City Center West

Accessibility Review

Transition Plan - (location/priority)

Photo 3: Relocate the planter that currently obstructs the pull side clearance to the small meeting room (103).

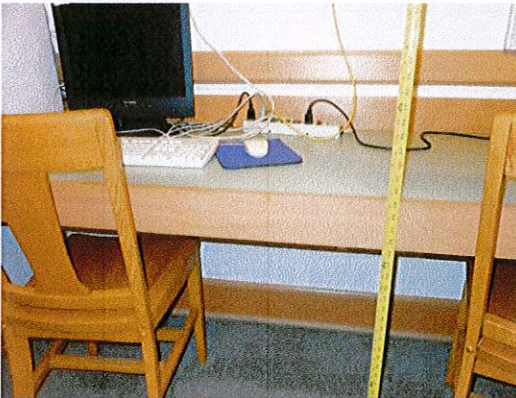
22H1	15532	Provide staple style pulls on both sides of the accessible stall door near the latch. ANSI 604.8.3		1	\$50	\$50	3		
22Q	15534	Insulate or otherwise protect exposed pipes at lavatory. ICC / ANSI 606.6		1	\$50	\$50	3		
22Z	15533	Provide a coat hook positioned so the highest operable part is no higher than 48". ICC / ANSI 604.11		1	\$50	\$50	3		
<i>Location Subtotal:</i>						\$1,940			
Small Meeting Room / 103									
20B1	15551	Relocate object to achieve needed maneuvering clearance on the pull side of the door. ICC / ANSI 404.2.3, Table 404.2.3.1 <i>The plants currently obstruct the entry from the corridor. Photo 3.</i>		1	\$50	\$50	3
